Product Change Notice (PCN)

Subject: Transfer of back-end production for general-purpose linear IC products (SOP package products)

Publication Date: 1/19/2024

This notice is to notify the transfer of a Back-End Factory.

SOP-14 :

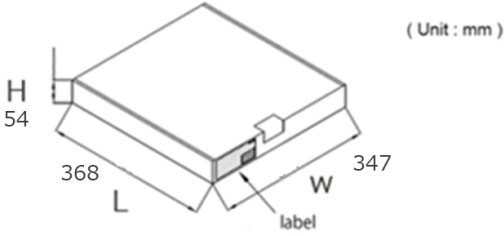
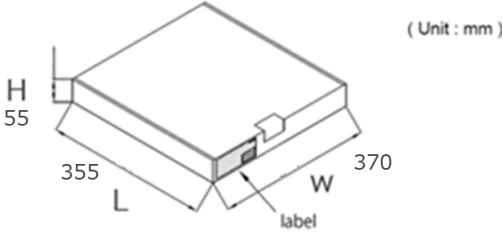
There are some dimensional differences in the outline drawing, but the recommended foot pattern remains the same.

(UNIT:mm)	
ITEM	DIMENSIONS
A	10.2±0.2
B	1.42MAX
C	1.27(T.P)
D	0.40±0.05
E	0.1±0.1
F	1.59±0.20
G	1.49
H	6.5±0.2
I	4.4±0.1
J	1.05±0.15
K	0.2±0.07
L	0.6±0.20
M	0.1MAX
N	0.1MAX
P	4°±4°

The packaging box size of the tube product is different as follows.
 This is standard specifications that have been mass-produced.

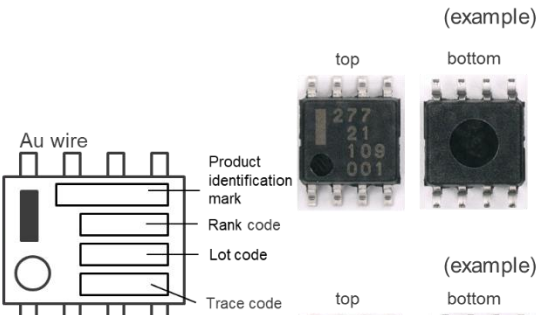
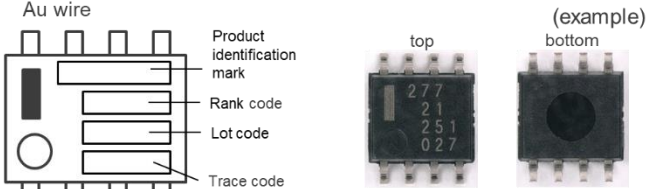
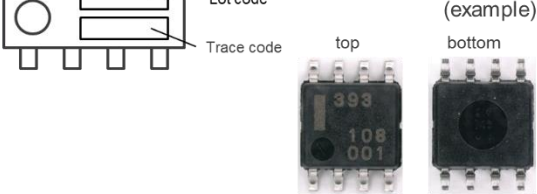
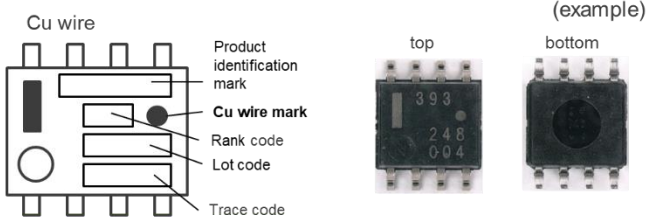
The size of the tube is different as follows.
 The tubes are open products and have a track record of mass production.

Current products (L×W×H)	UTL products (L×W×H)
540×125×85 (mm)	532×135×85 (mm)

SOP-8 :

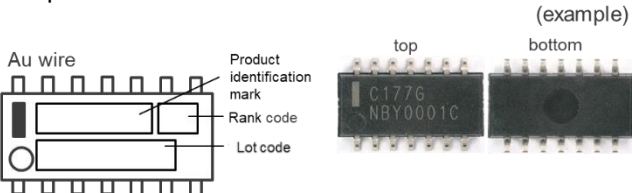
The appearance (typeface) of the marking/outline of high-quality products is different, but the marking/outline information is the same.

The appearance of the marking/outline of the standard product (typeface, Cu wire identification mark added) is different, but the marking/outline information is the same. (The marking drawings of the delivery specifications differ only in the standard level.)
